OIA IRO-383

Official information request for held information on 106 Mohaka Street, Wainuiomata.

Official information request for held information on 106 Mohaka Street, Wainuiomata.

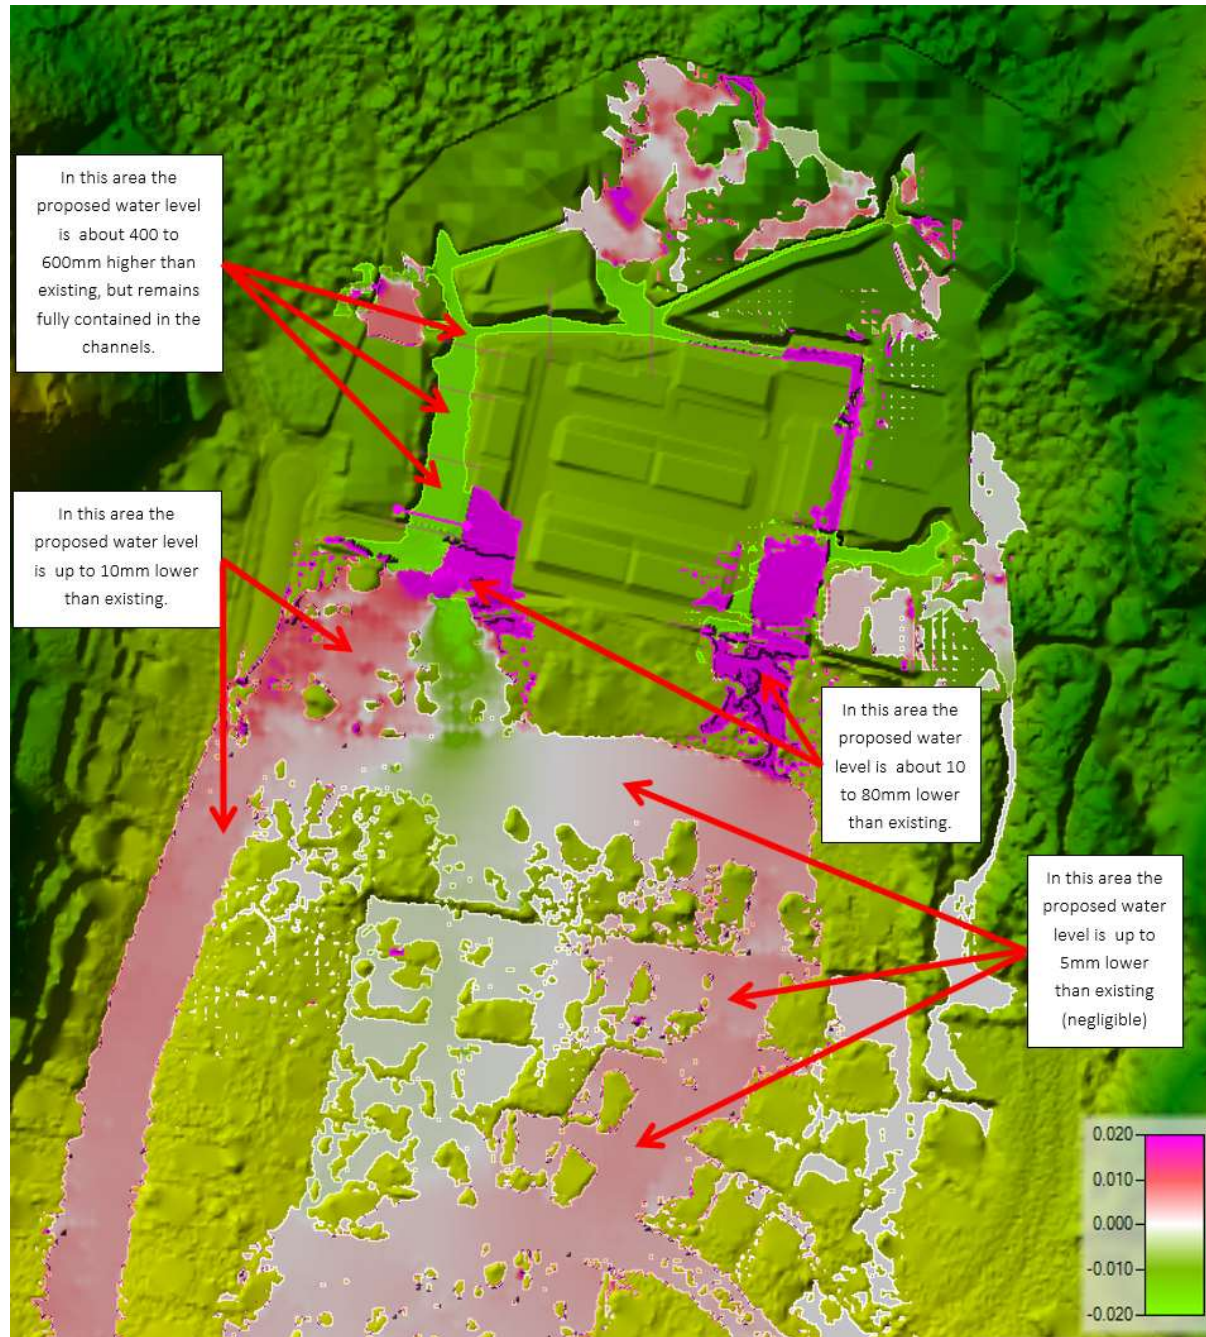
Offsite impacts: I would like to see a difference map (if possible) of pre and post development flood depths to confirm “no more than minor” effects, particularly downstream of the site. If the boundary drains are not as efficient in the pre-development scenario as has been modelled, then greater downstream impact may be seen post development.

Response: We have updated the previously supplied Please pre and post development 100yr ARI water surface elevation, depth and velocity maps in sheets 12 to 17 of the calculations, and a flood level surface comparison map in sheet 18 (reproduced again in the figure below).

Figure 10: Comparison existing WSL and proposed WSL

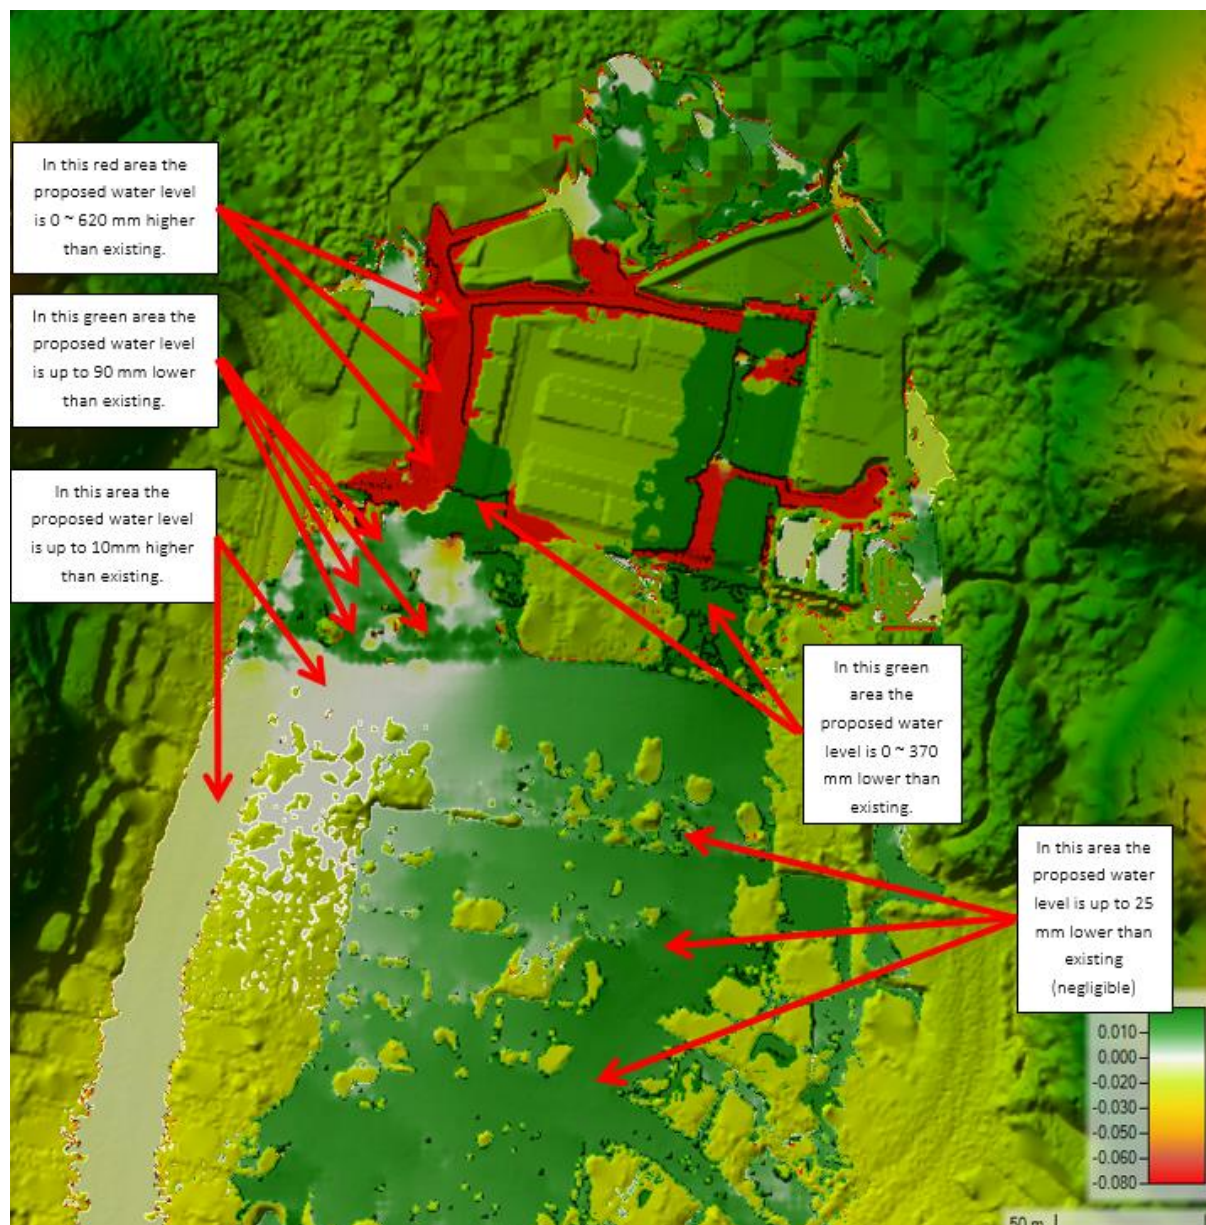
I am a little unsure about the downstream impacts, particularly on properties 100 – 104 Mohaka St and 3-5 Rakaia Gr. Would it be possible to revise the pre and post difference map (Figure 10) to show if there are any areas with ≥ 50 mm difference. The pre and post water level maps do not seem to align well with the difference map (Figure 10).

Downstream of the development, the revised 100yr ARI flood levels are predicted to decrease at west-southern and east-southern location, typically up to 370 mm by each location (green), as shown in Figure 10 below.

In case of west-southern downstream impact, particularly on properties 100-104 Mohaka and 3-5 Rakaia Grove's proposed flood level is reduced up to 90 mm. as shown in Figure 11, 12, 13, 14 and 15 below, respectively.

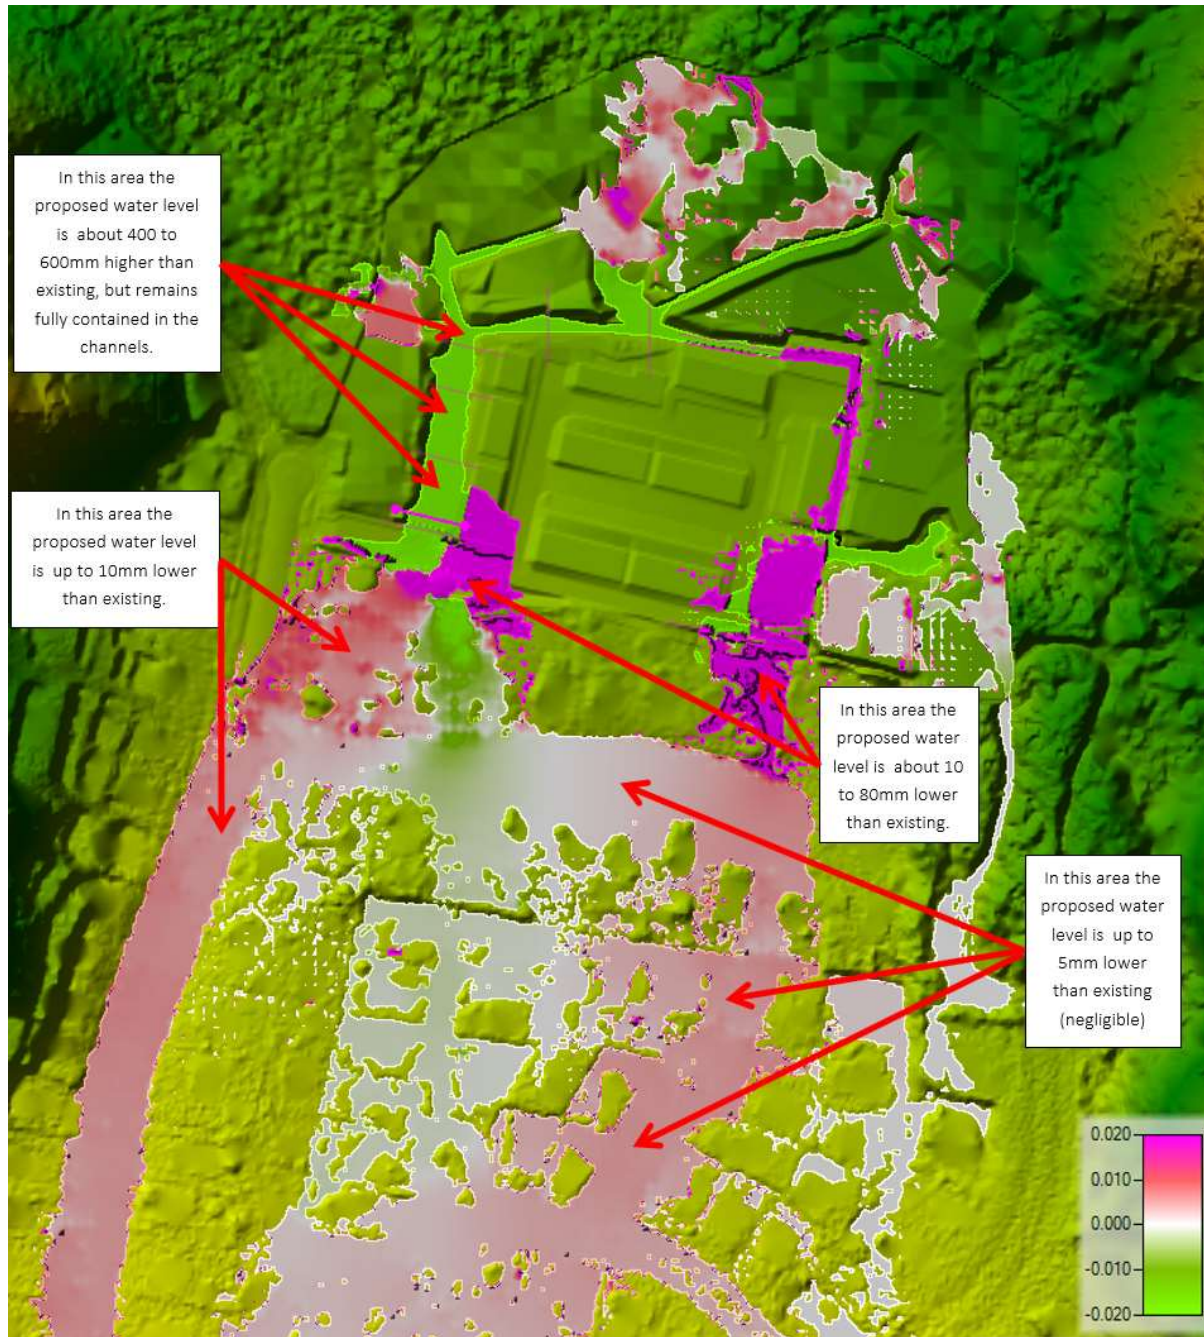
Offsite impacts: I would like to see a difference map (if possible) of pre and post development flood depths to confirm “no more than minor” effects, particularly downstream of the site. If the boundary drains are not as efficient in the pre-development scenario as has been modelled, then greater downstream impact may be seen post development.

Response: We have updated the previously supplied Please pre and post development 100yr ARI water surface elevation, depth and velocity maps in sheets 12 to 17 of the calculations, and a flood level surface comparison map in sheet 18 (reproduced again in the figure below).

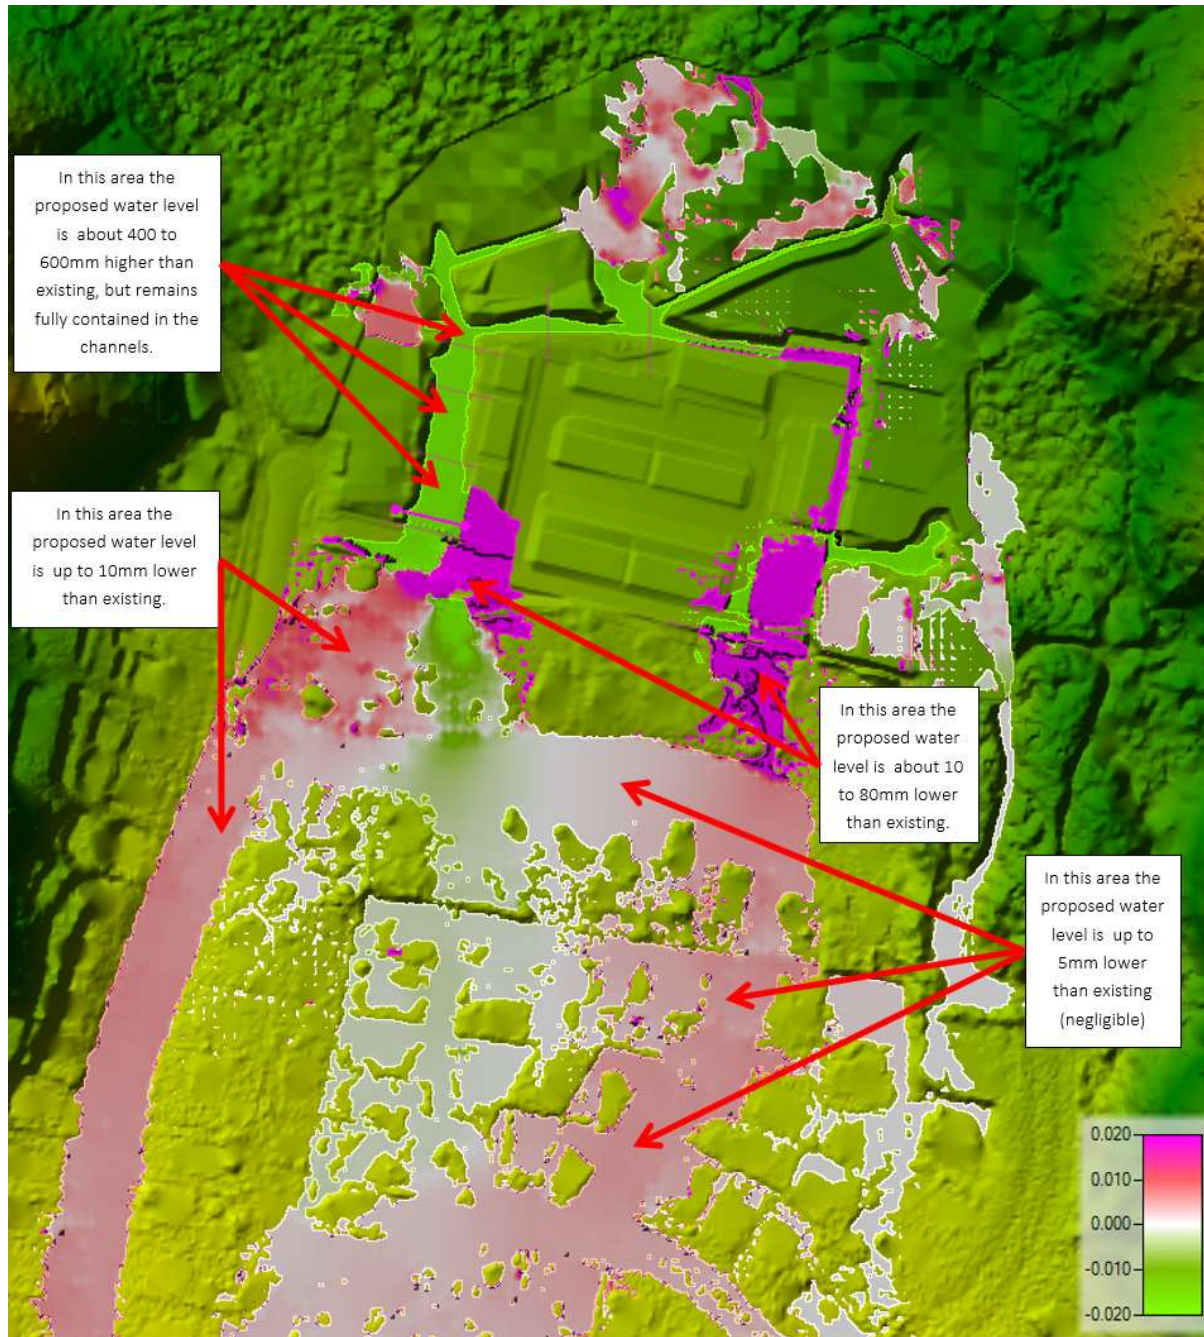
Offsite impacts: I would like to see a difference map (if possible) of pre and post development flood depths to confirm “no more than minor” effects, particularly downstream of the site. If the boundary drains are not as efficient in the pre-development scenario as has been modelled, then greater downstream impact may be seen post development.

Response: We have updated the previously supplied Please pre and post development 100yr ARI water surface elevation, depth and velocity maps in sheets 12 to 17 of the calculations, and a flood level surface comparison map in sheet 18 (reproduced again in the figure below).

B FLOW PATH SECTION
451 SCALE: 1:10 @A1
1:20 @A3

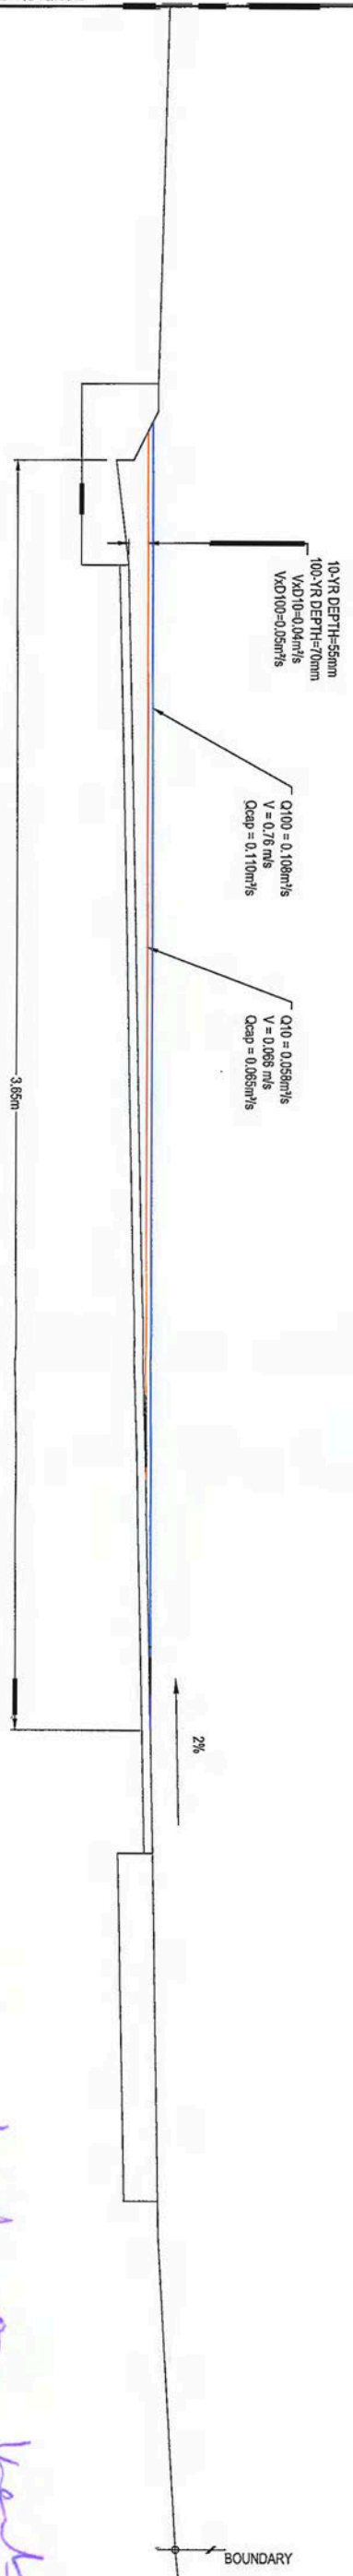
- The Peak flow rate in 10 yr ARI rainfall even will be 40 l/s in the worst case position (See Section B drawing 430 on plan 451). Section C has a lesser impact as it does not directly cross the road. In addition based on the 12hr storm duration the peak flows usually last for 2-5 minutes only.
- DxV (depth x velocity) is 0.03 which is well below the recommended 0.4.
- The 10yr ARI peak flow depth at the worst section will be around 55mm. (See updated section on drawing 430)
